APPLE-1 JUKE-BOX 4 Mbit IMPROVEMENT

v1.09 / v1.09a

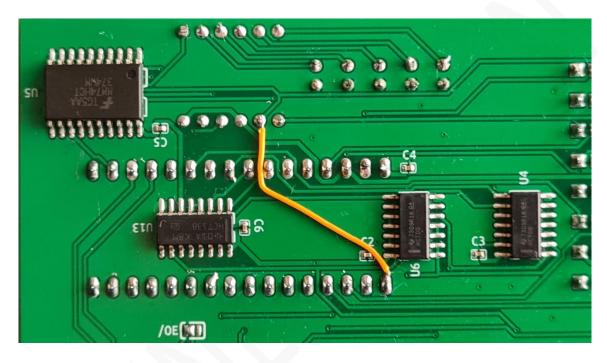
Tuttavia, per rendere la board completamente compatibile con le memorie FLASH della serie **29c040 / 39sf040 da 4 Mbit** è necessario aggiungere il collegamento riportato in figura.

However, to achieve the full compatibility with 4 Mbit FLASH 29c040 / 39sf040, it will be necessary to add the small wiring as shown in the picture above.

Questa modifica è applicabile solo alle board con versione di PCB 1.09 e 1.09a.

Se si utilizzano solamente EPROM/FLASH da 2 Mb, come quelle fornite di serie (27c020 / 29c020) tale modifica non è necessaria, ma se effettuata non crea problemi di alcun genere.

This modification is intended only for boards with PCB version 1.09 and 1.09a.

If you only use 2 Mb EPROM/FLASH, such as those originally supplied (27c020 / 29c020), this modification is not necessary. If made, it will be harmless.
